#### Question from TDC:

#### "Impact upon Abingdon

## HIF1 Project Team Response:

# Walking and Cycling

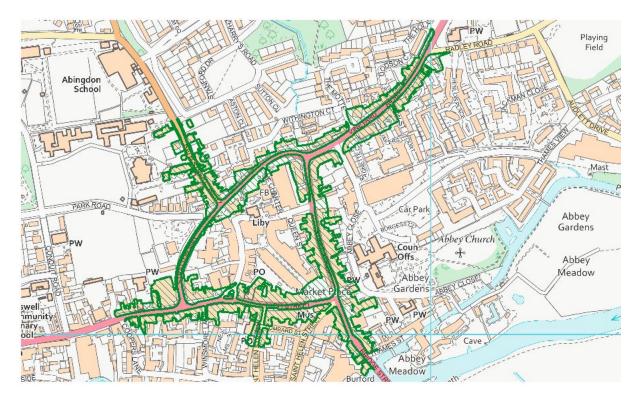
There have been several representations made (and there is likely to be more from Members/TC's/PC's etc) about the impacts on Abingdon town centre, as a result of the HIF1 schemes and this is something I will have to address in my response. Obviously the Paramics Model stops just to the west of the existing Culham River Crossing and no further junction capacity modelling has been done for any of the junctions in the centre of Abingdon. I know that the County approach is very much looking towards decide and provide and therefore, would not expect larger capacity to be provided in this area, but for people to look towards the cycle infrastructure that is being provided as part of the scheme, however, for the purposes of transparency it would be helpful if you were to provide some clarification/justification about why no assessment has been done here, given that there are existing queues back along the A415 into Abingdon. Members may want to understand if the queues will remain/change as a result of the HIF1 schemes/if there is a net increase of vehicles travelling north along the A415 to Abingdon."

The Scheme both directly delivers and indirectly enables a significant number of new and/or improved walking and cycling routes in the area. The provision of additional and improved NMU routes and crossing points will help to reduce the existing severance caused by the Great Western Mainline and River Thames. Connections to public rights of way will be provided, and safe access to and from new bus stops. This will help to engender modal shift away from the private motor car, particularly for commuting purposes for employment and education, but also for important access to amenities such as retail and healthcare, and for leisure trips. As explained below under 'Housing Sites', development sites in the area will be required to deliver additional NMU links which will connect with the HIF NMU infrastructure, in turn linking Didcot (and surrounding areas) to Abingdon with high quality NMU routes.
